PRODUCT
SUPPORT
BULLETIN # 152

TOOL(S)/PRODUCT(S) AFFECTED: 6890 16 Gauge Nibbler

SUBJECT: Steel Locating Pin in 28-14-1860 Gear Case Assembly

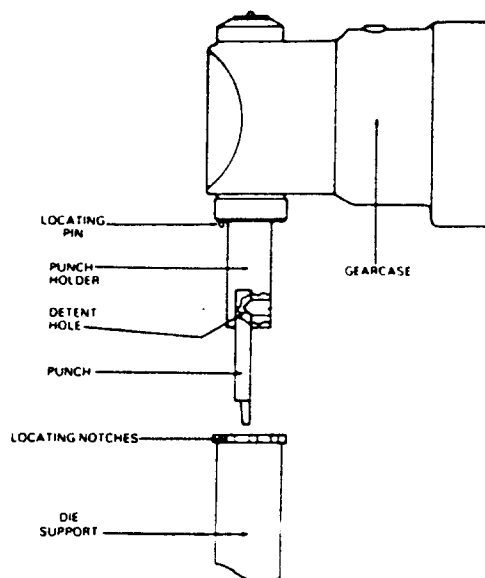
06-65-1525 5/64 x 3/8 roll pin can be used as replacement for the solid steel locating pin in the 28-14-1860 gear case assembly. (See illustration).

This bulletin is for informational purposes; please note on Service Parts List 54-27-0640.
